SERVICE BULLETIN

NUMBER: SB 500-52-008, REV B
MODEL: ECLIPSE EA500
SUBJECT: MAIN LANDING GEAR-LOWER DOOR AERO SEAL MODIFICATION

Main Landing Gear-Lower Door Aero Seal Figure 1

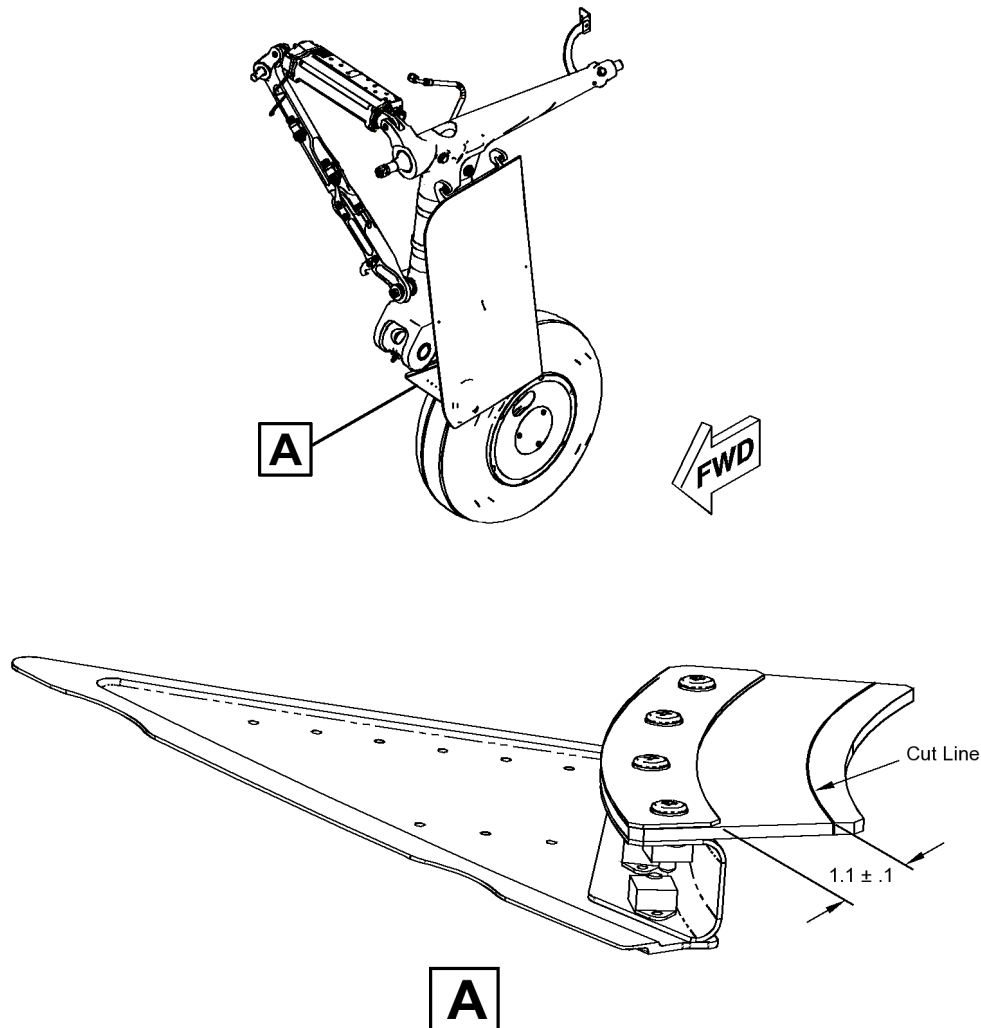
Performance of this modification will prevent the possibility of interference between the main landing gear lower aero door seal and main gear tire.

This Service Bulletin reworks the Aero Seals on each Main Landing Gear-Lower Door for adequate clearance from the tire.

- (1) Make aircraft safe for maintenance. Refer to AMM 20-00-01.
- (2) Remove left Main Landing Gear-Lower Door. Refer to AMM 52-82-11 Main Landing Gear-Lower Door Assembly Removal
- (3) Mark and rework aero seal (P/N 52-109214-2002) to obtain $1.1 \pm .1$ inch from retaining bracket (P/N 52-114011-2001). Refer to [Figure. 1](#).
